# Product Change Notification (PCN)

PCN Number	510498	Date Issued	September 07, 2021
Reason for Change	Capacity change or tool replacement		
Change Type Description	This letter is to inform you that another set of tooling is being added to meet the current and future demands of this product. There will be no changes in the fit, form or function from the additional tooling when compared to the current tooling.		
Reason for Short Notice	New Capacity		
Assessment of Change	Product will be fully qualified before it is shipped. Qualification reports will be available after below listed date		
Internal Molex Qualification Date	August 16, 2021		
Sample Availability Date (Changed Part)	August 16, 2021		
Planned Implementation Date	October 08, 2021		
Method of Identifying Change	Date code

- 0457761008 / 0457763008 Picture as below

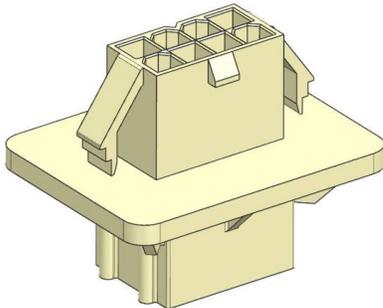
- New capacity add in Shanghai to support the growth demand.
- Product Impact**
  - no impact to fit, form or function
- Part Number Impact**
  - 0457761008 & 0457763008
- Qualification Reports and samples available upon request after the date shown above
